#62-F-243C
WP. #175-61
HWY #401
LA RUE MILLS
ROAD
UNDERPASS

Re: Foundation Conditions
La Rue Mills Road Underpass
Hwy. 401, W.P. 175-61

W.P. 175-61, Bridge Site No. 17-138,
LaRue Mills Road Underpass at Twp. Rd.
to LaRue Mills, Hwy. 401, District 8.

FOUNDATION INVESTIGATION REPORT BY -
Wm. A. Trow & Associates, Limited,
La Rue Mills Road Underpass, Hwy. #401,
District #8 -- W.P. 175-61.

PROJECT NO. I. 968 W.P. NO. 175-61 DATE NOV. 1962 DWG. 1.

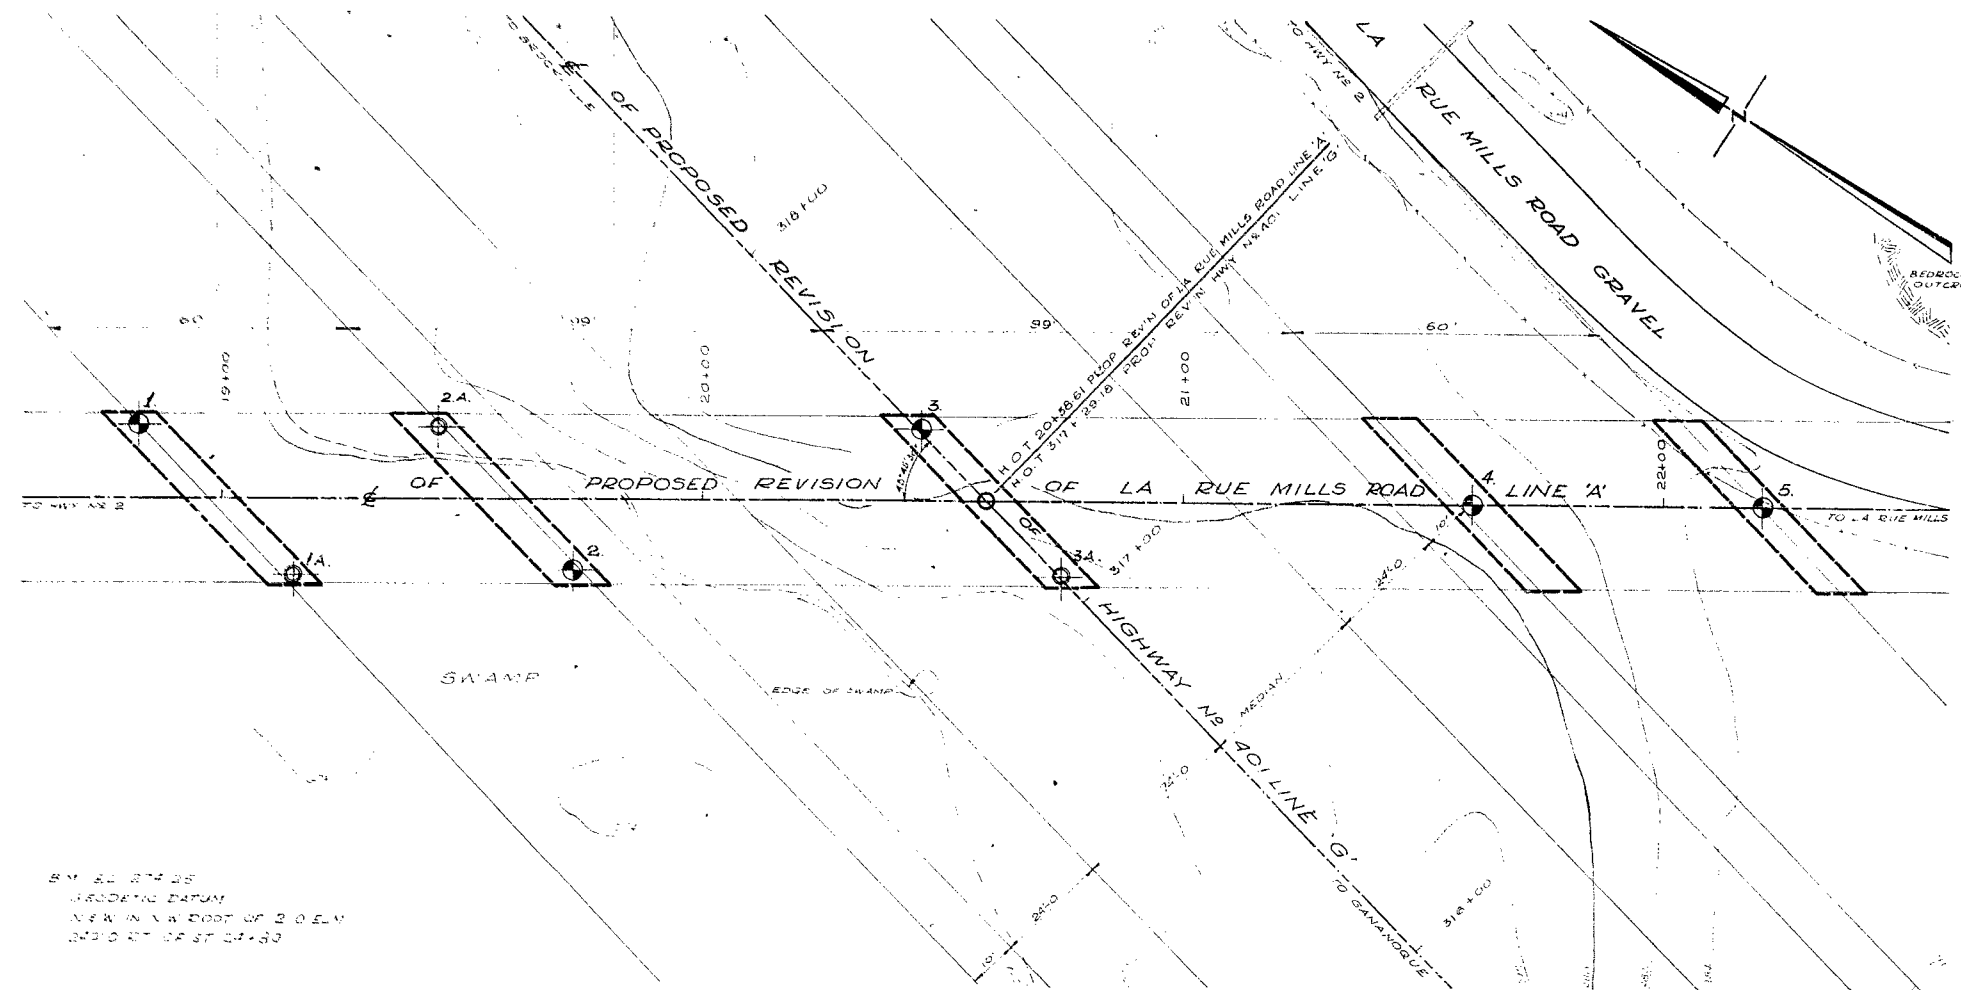
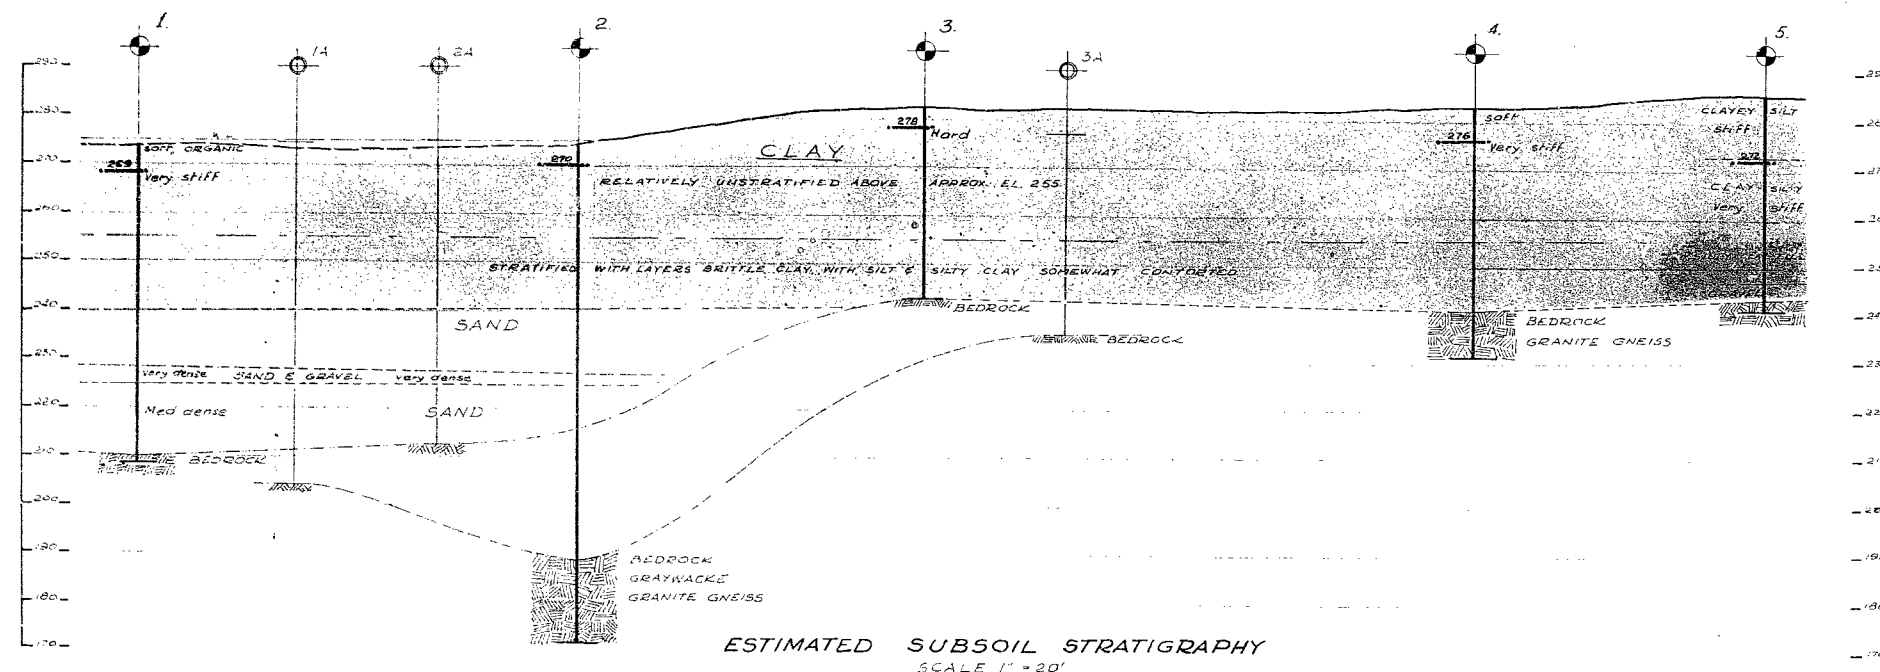
Due to the extreme irregularity of the depth of bedrock, and the presence of a very dense sand and gravel stratum of variable thickness, it is difficult to predetermine the lengths of piles required. We therefore, recommend the use of spread footings for foundations of all piers and abutments in order to avoid construction problems. In any case, if foundations employing piles driven to bedrock are contemplated, another investigation has to be carried out in order to determine the surface bedrock in greater detail.
